MCPB  
1/22/98  
Item #9

MEMORANDUM

(301) 495-4584  
 VIA: Charles Loehr, Chief *CL*  
 Development Review  
 REVIEW TYPE: Site Plan Review  
 APPLYING FOR: 768 units: 75 SFD, 295 Townhouses, 398 multifamily inclusive of 96 M<sup>2</sup>DU's  
 PROJECT NAME: Clarksburg Town Center - Phase I  
 CASE #: 8-98001  
 REVIEW BASIS: 59-D-3 of the Montgomery County Code is required for the optional method of development in this zone.  
 ZONE: RMX-2, Residential Mixed Use Development, Specialty Center  
 LOCATION: Northeast of the intersection of Clarksburg Road and Stringtown Road  
 MASTER PLAN: Clarksburg Master Plan and Hyattstown Special Study Area, June 1994  
 APPLICANT: Clarksburg Land Associates L.P. and Piedmont Land Associates L.P. and T/A Clarksburg Town Center Venture  
 FILING DATE: August 1, 1997  
 HEARING DATE: January 22, 1998

Applicant's Proposal 30

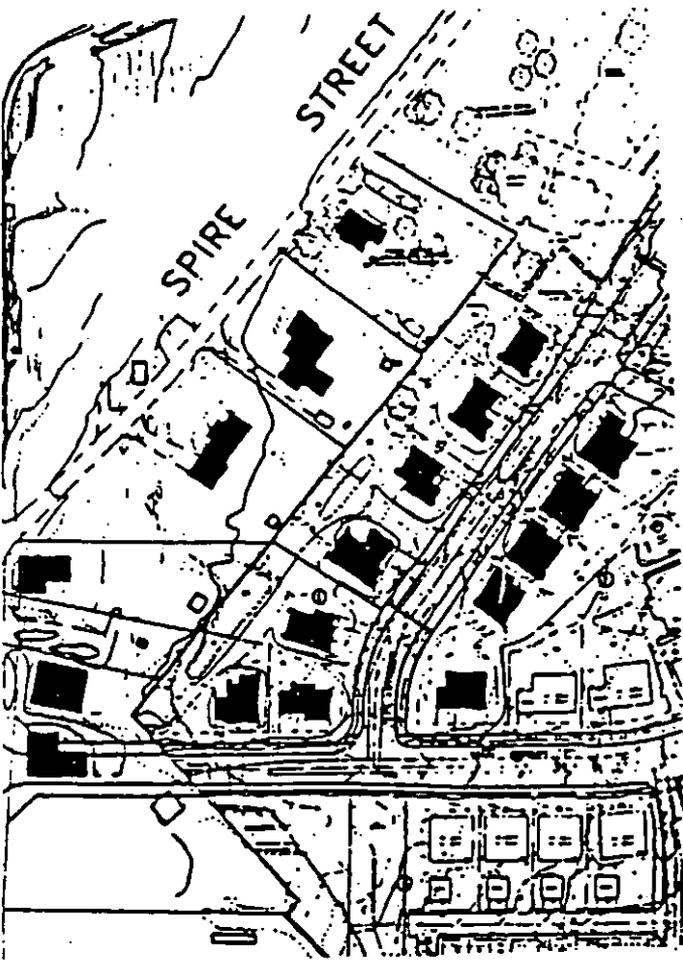
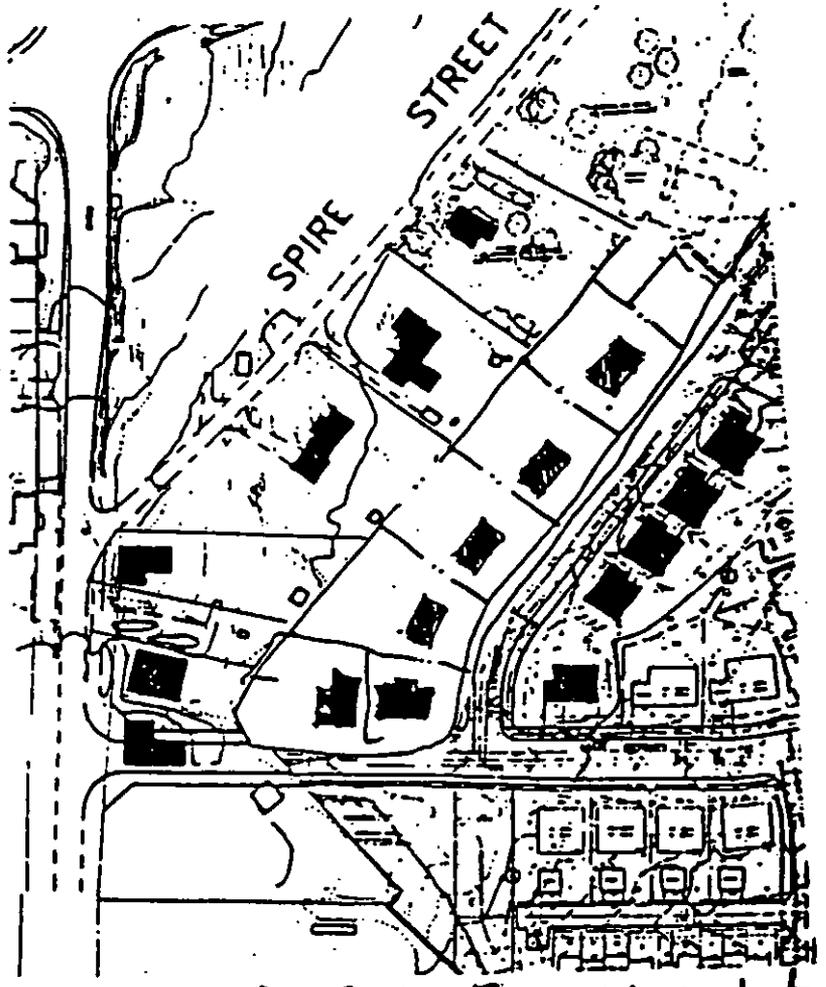
32. One lot should be deleted from the single family home area directly adjacent to the Historic District, to fulfill the Project Plan condition to approximate R-200 zone lot width standards.

The removal of a proposed house is to create compatibility between the two projects utilizing similar scaled and dimensioned buildings and surrounding open spaces. The existing condition on Spire Street has three homes that have lot widths at their building face of 130 ft, 115 ft and 180 ft. The lots along MD 355, whose rear yards adjoin the common boundary, have 40 and 60 foot widths at the front building line. The proposed six lots have 2 lots with 68 foot widths at the front building line, one lot at 65 feet, one lot at 990 feet, one lot at 88 feet and one lot at 120 feet. The average frontage for all six lots is 83 feet. The approved Project Plan condition reads: "...the size of lots and setbacks of the proposed development must match, approximately, the development standards in the R-200 Zone for building setbacks and width of lots along the southeastern boundary of the site..." The required lot width along the front building setback line is 100 feet. The dimensions of the proposed lot widths and the sketch below show the lack of conformance with the desire of the HPC and the Planning Board's earlier decisions. The staff proposal clearly shows that the 100 foot lot widths work to create an appropriate transition between the existing Historic District and the proposed units. See memo of January 15, 1998 from the Historic Preservation Commission in the Appendix.

Staff's Recommendation
